SR 92 Improvements from US 41/SR 3/Cobb Parkway to Glade Road

Project Numbers: CSSTP-0006-00(862) and BRST0-0213-01(005)

Value Engineering Study Report Design Development Stage

March 2009

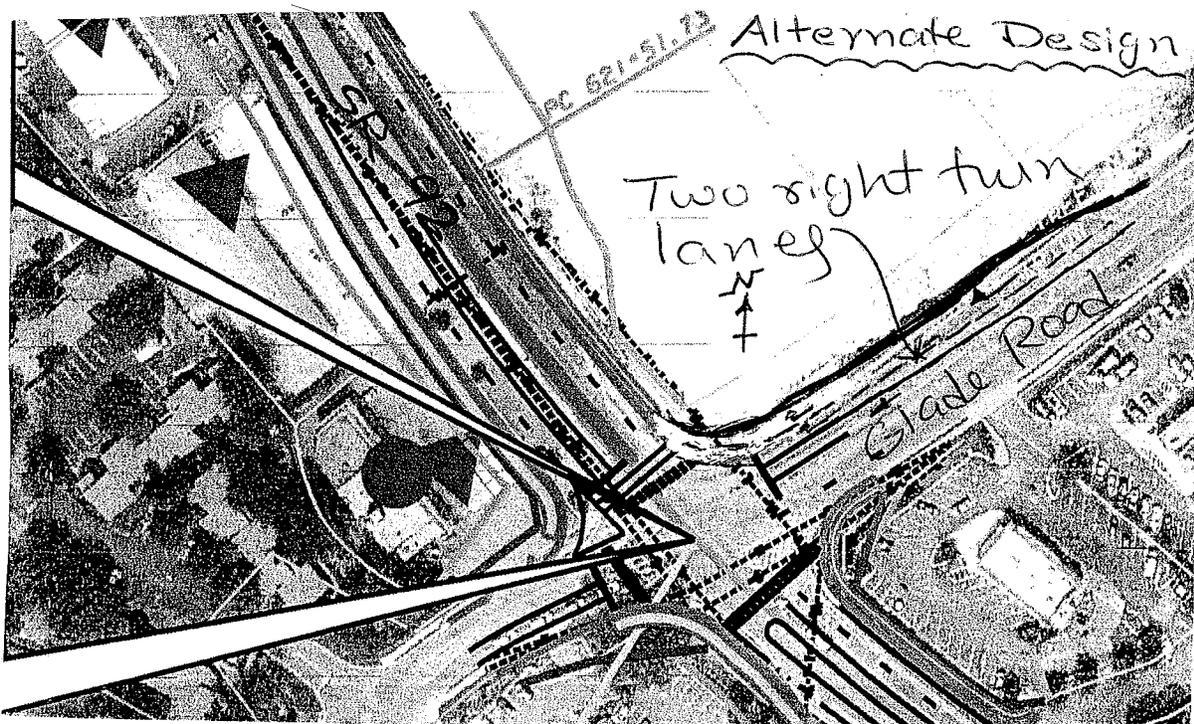
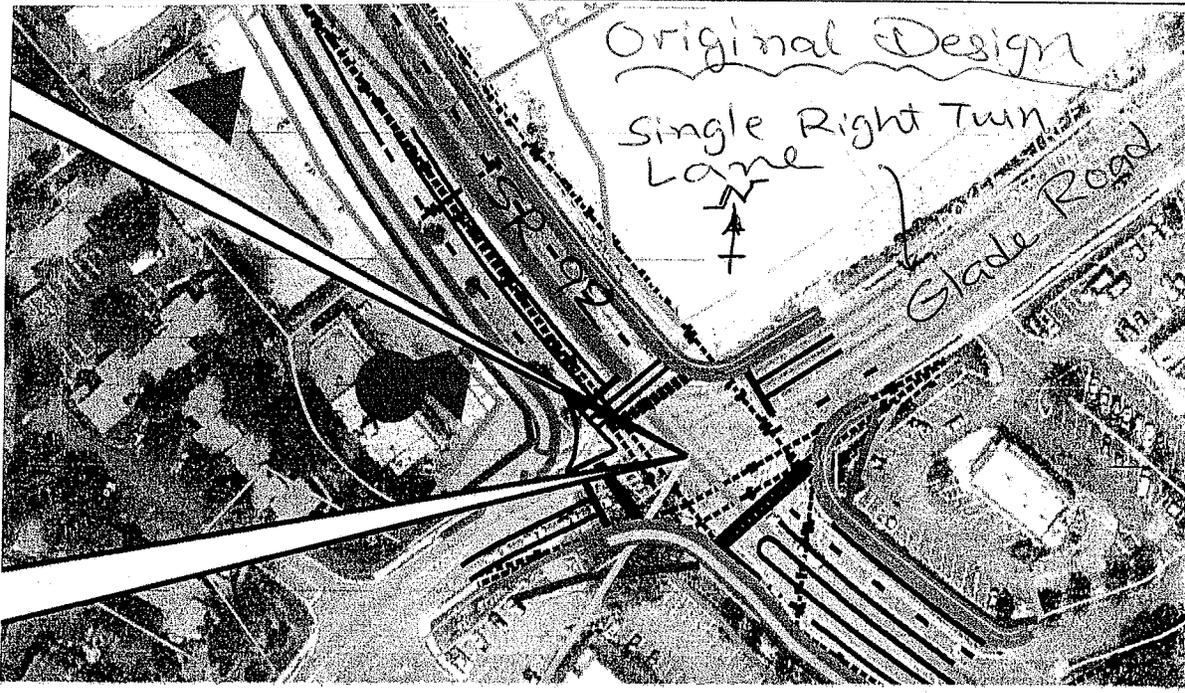
Provide two right turn lanes from Glade Road to westbound SR 92.

Glade Road intersects I-75. The 2007 ADT shows that 5,300 vehicles currently make a right turn from Glade Road to SR-92. This heavy traffic is expected to rise to 7,890 in the year 2032.

Two right turn lanes will significantly improve traffic flow from southbound Glade Road to westbound SR 92 which is currently operating at LOS 'D' and is expected to operate at LOS 'F' in 2032.

Sketch Alt. R-3

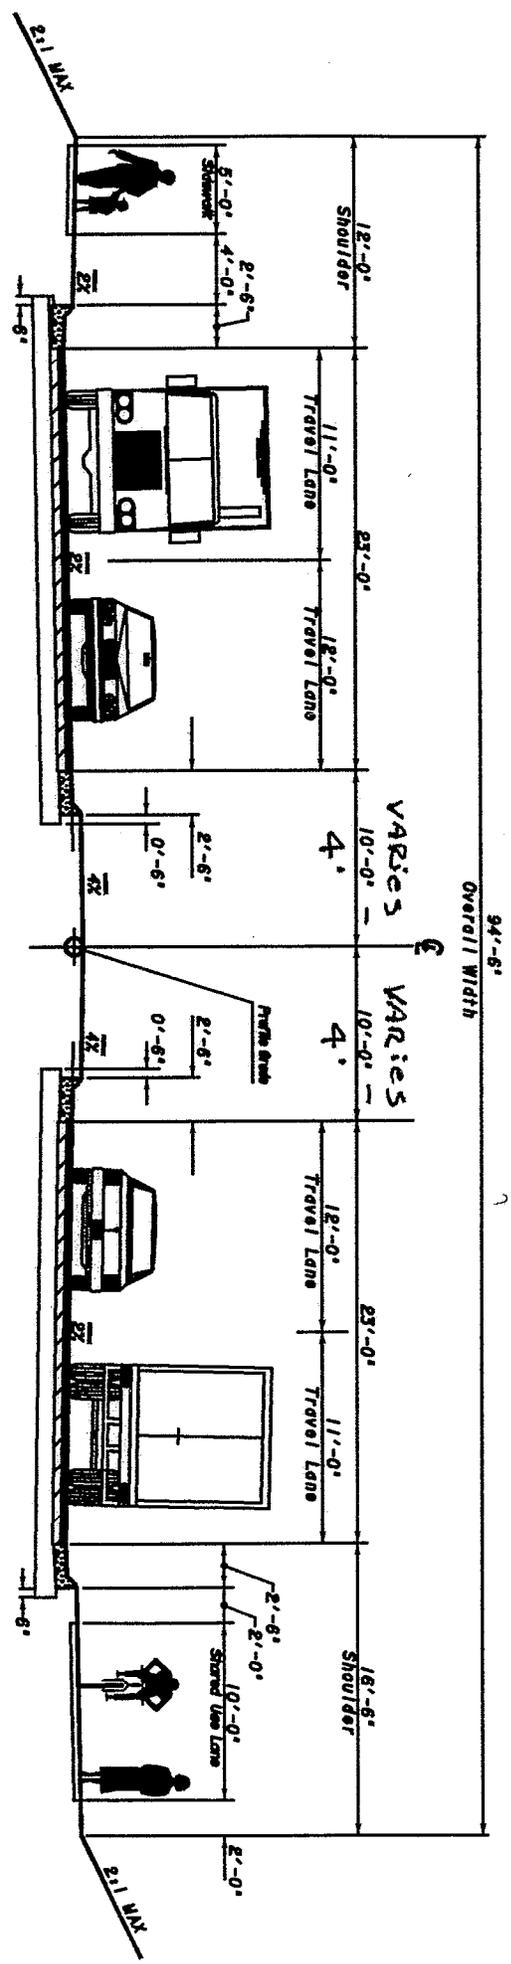
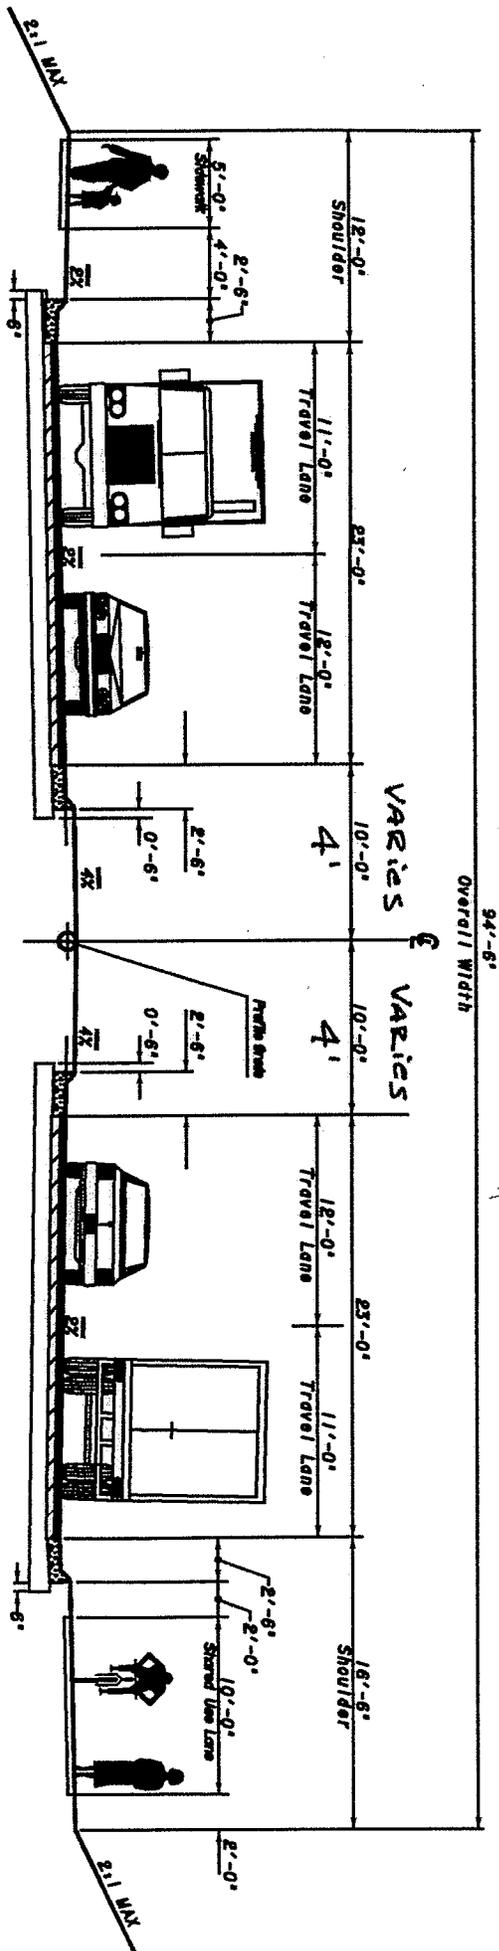
DESCRIPTION: **MAKE ALL INSIDE LANES 11-FT-WIDE IN LIEU OF 12-FT-WIDE** SHEET NO.: **1 of 7**

Original 12' inside lanes

Alternate 11' inside Lanes

AH.R-5

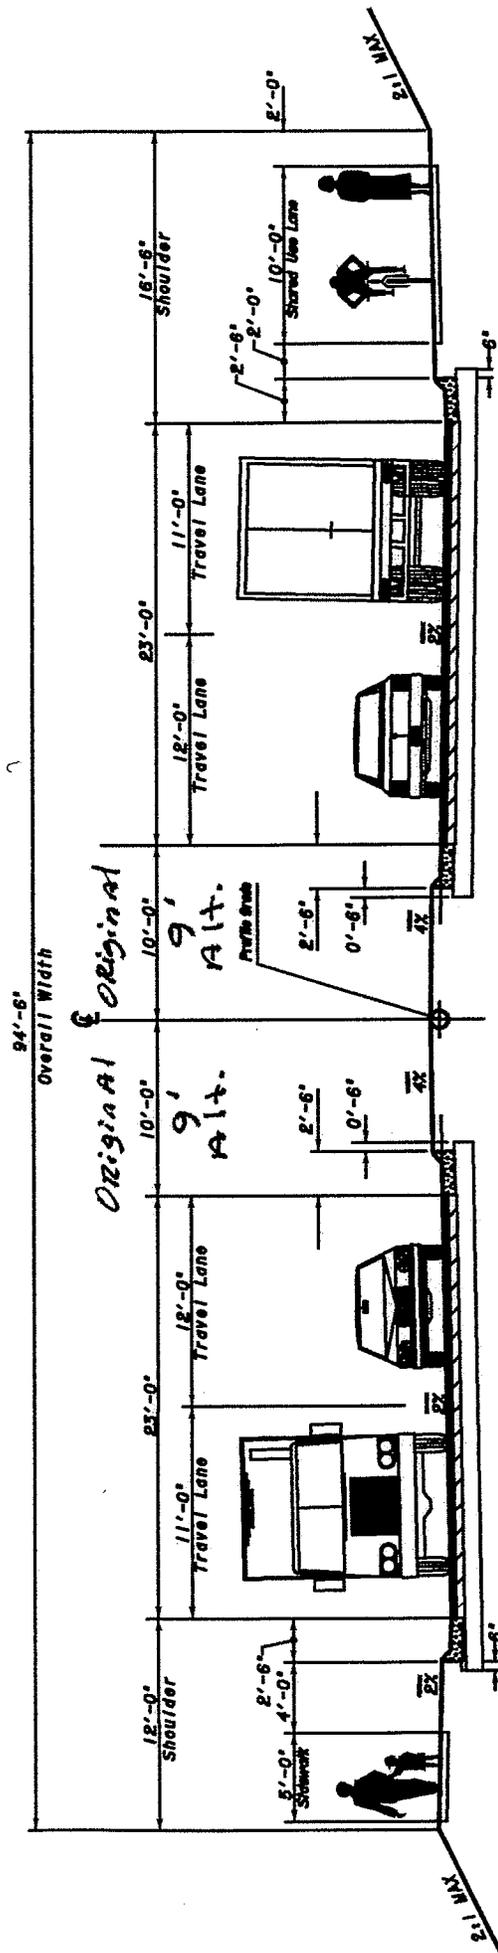
Original & Alternate
(20') (18')

Sketch Alt. R-6

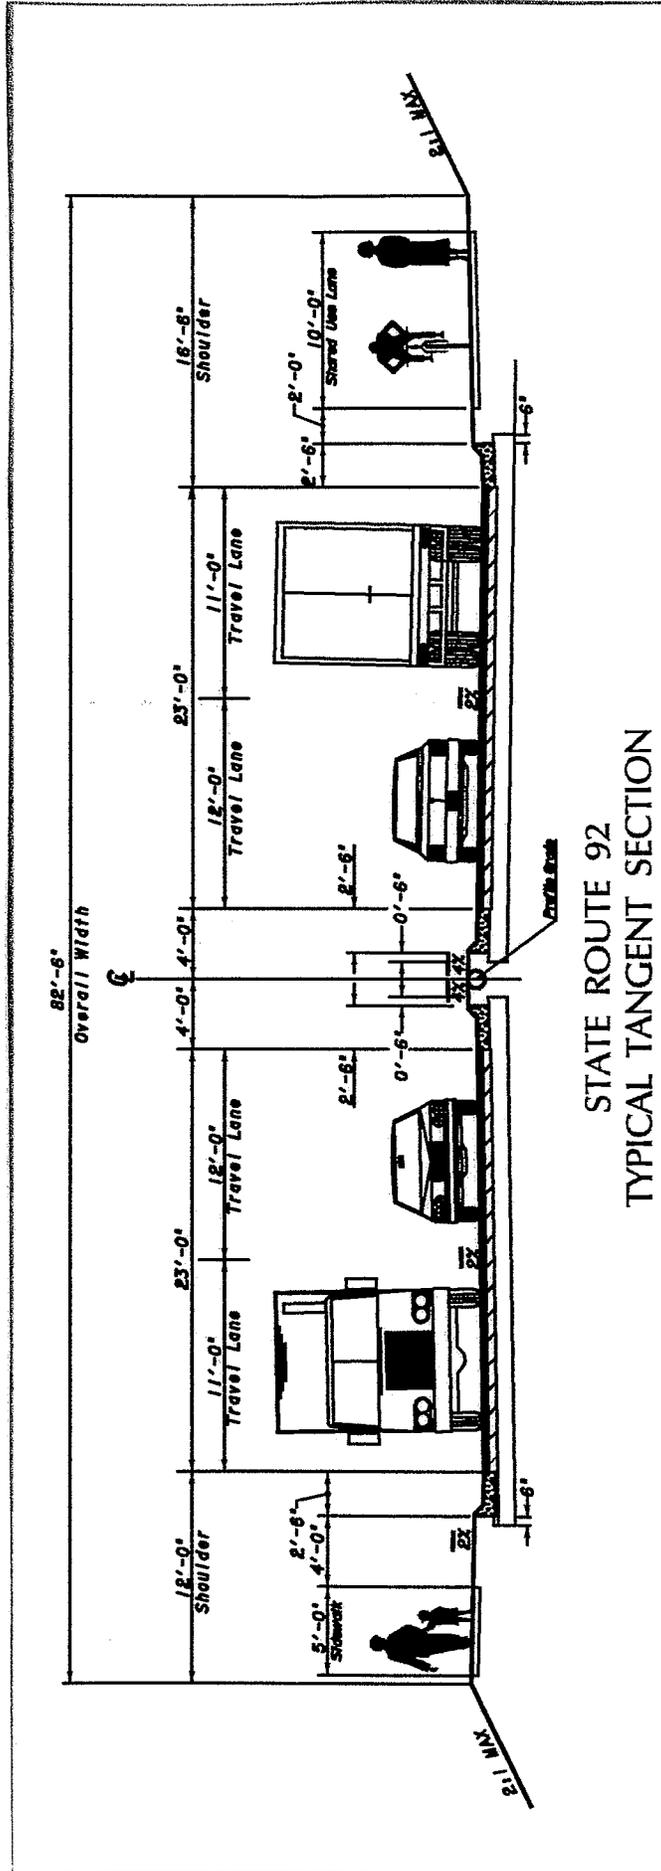
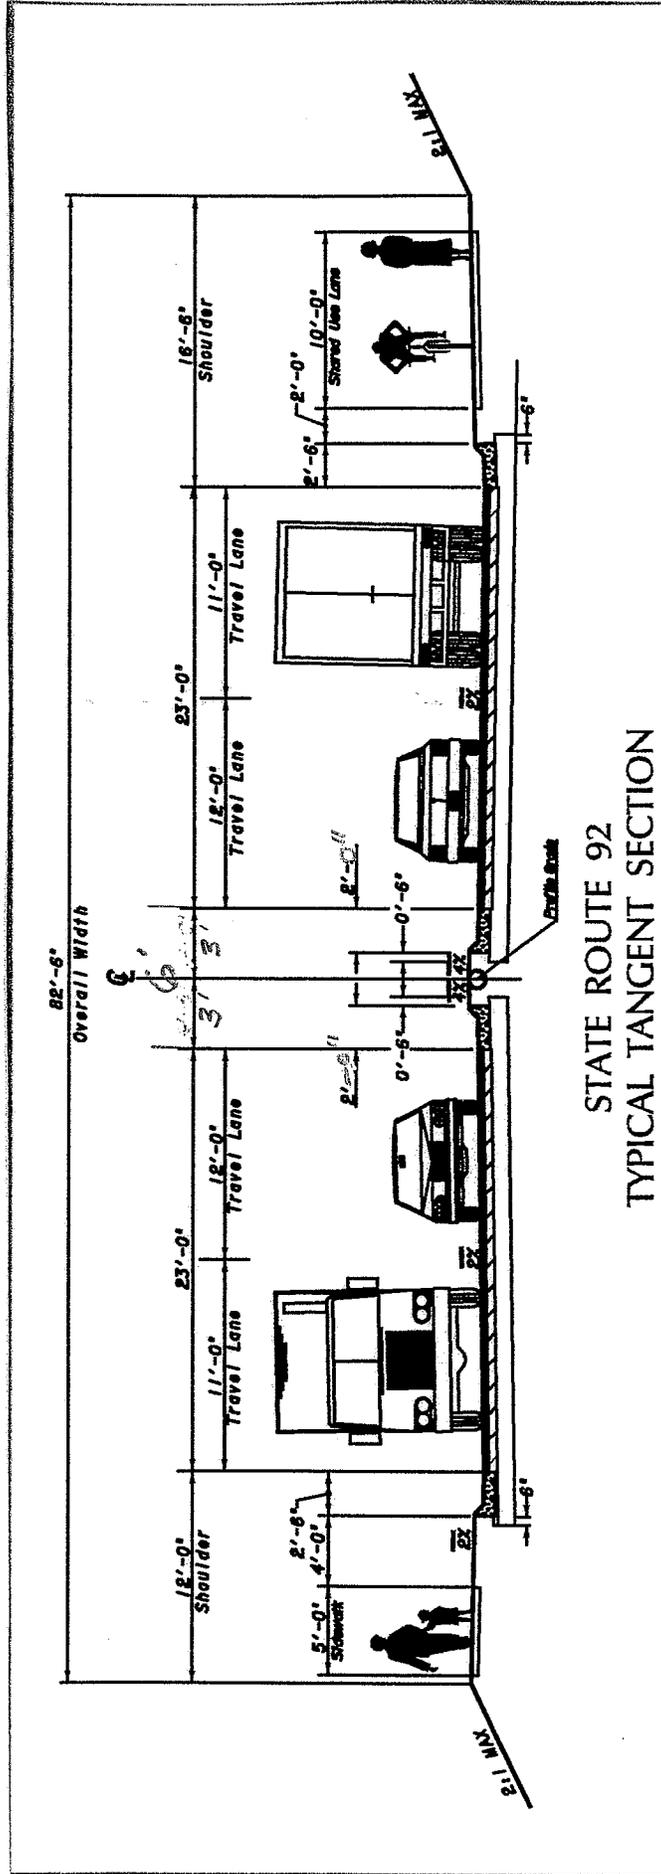
PROJECT:	SR 92 Improvements from US 41/SR 3/Cobb Pkwy to Glade Rd. P.I. Nos. 0006862 and 731865 <i>Cobb County, GDOT District 7</i> <i>Design Development Stage</i>	ALTERNATIVE NO.:	R-6
DESCRIPTION:	MAKE THE ROADWAY MEDIANS 6-FT-WIDE WITH 24-IN-WIDE CURB AND GUTTER IN LIEU OF 8-FT-WIDE WITH 30-IN-WIDE CURB AND GUTTER	SHEET NO.:	1 of 7

Original 2/7
8' median

Alternate: 3/7
6' median

ALT. R-7

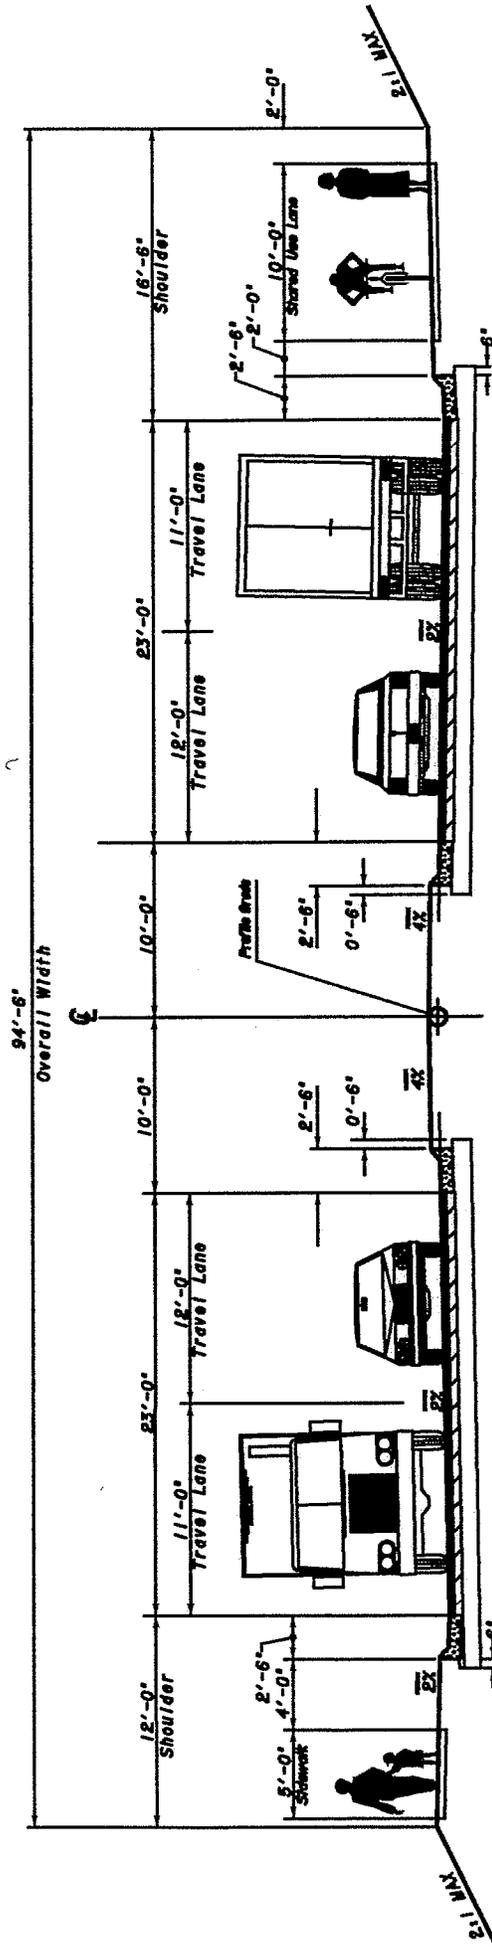
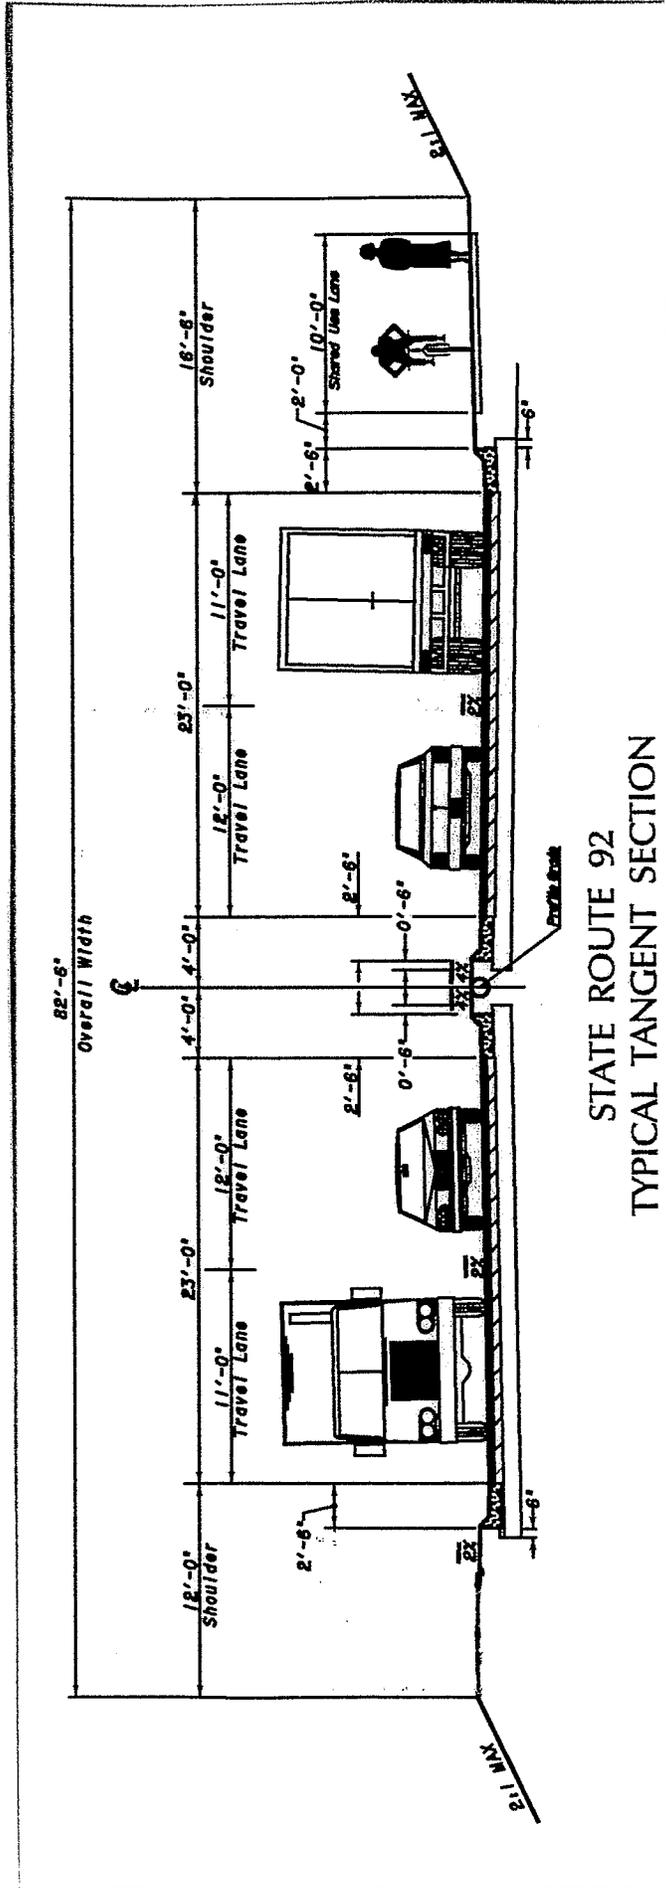
Remove the sidewalk from the left side of SR 92 except where necessary. The VE team estimated that a total of 1,500 LF of sidewalk on the left side should be sufficient in the busy commercial areas.

Original Shoulder
with sidewalk

ALTERNATIVE NO.:
R-9

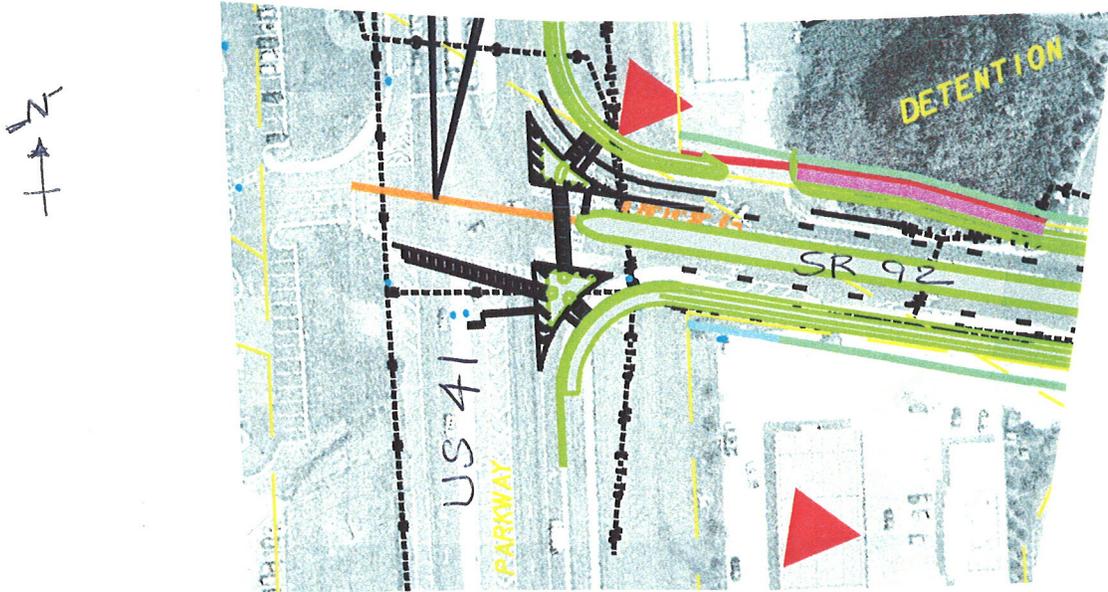
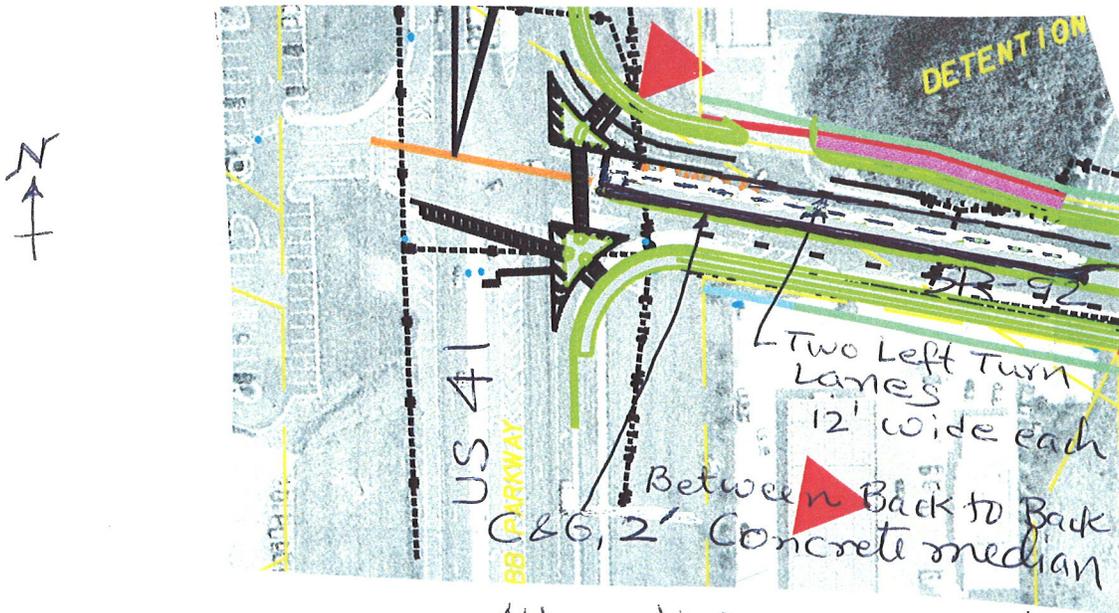
Provide a second left turn lane from westbound SR 92 to southbound US 41.

As - Designed

Alternative
